Office Action Summary	Application No. 10/525,703	Applicant(s) RUOTOISTENMAKI, HEIKKI	
	Examiner MICHAEL C. STOUT	Art Unit 3736

DETAILED ACTION

This detailed action is in regards to United States Patent Application 10/525703 filed on 8/3/2005 and is a first action based on the merits of the application.

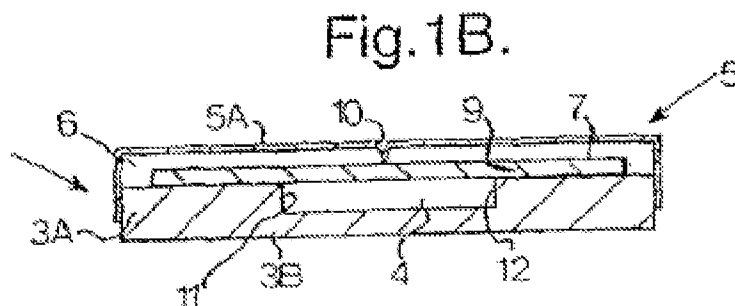
Freakes teaches a force or pressure sensor, comprising a substantially rigid, mechanical-load resistant frame (frame 3A), a flexible diaphragm secured over its peripheral rim to the frame (substrate 7), and a piezoelectric sensor diaphragm applied to the surface of the flexible diaphragm (SAWs device Y is laid down on the substrate, see Page 5, Paragraph 2) wherein the sensor diaphragm loading element comprises a substantially rigid cover capable of carrying mechanical loading (lid 5) wherein the cover includes a protrusion or shoulder (projection 10), bearing against a middle section of the flexible diaphragm and thus (see Figure 1B),

region of the substrate, see Abstract and Page 5, Paragraph 4), and wherein the frame and the cover define therebetween a closed housing chamber (see Figure above), the flexible diaphragm and the piezoelectric sensor diaphragm being located there inside (see Figure 1B).

FIG. 1

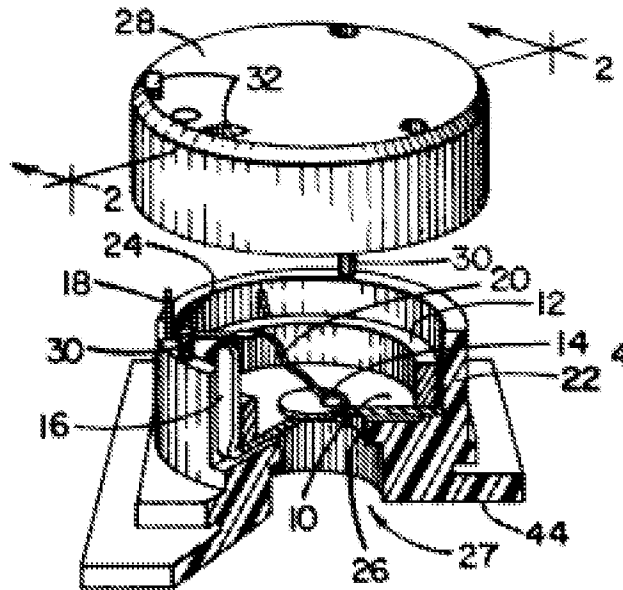
Guscott teaches a transducer device wherein the cover (28) and frame (22) and diaphragm (10) are rotationally symmetrical wherein the frame and cover comprise elements in the shape of bodies of revolution.

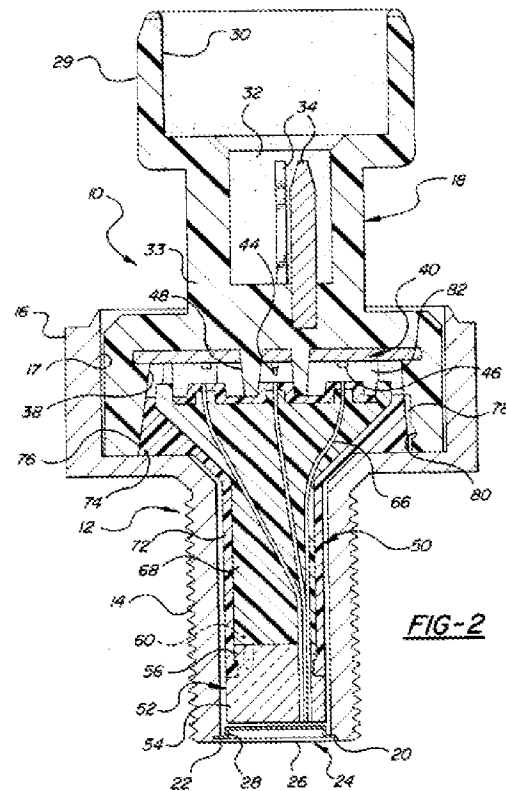
Rogne teaches a pressure sensor with a detection threshold D within a range of about 10^{-7} times the maximum load rating of the device, which is shown as the line F (Failure Line), see Figure 5 and Page 7, Lines 25-30.
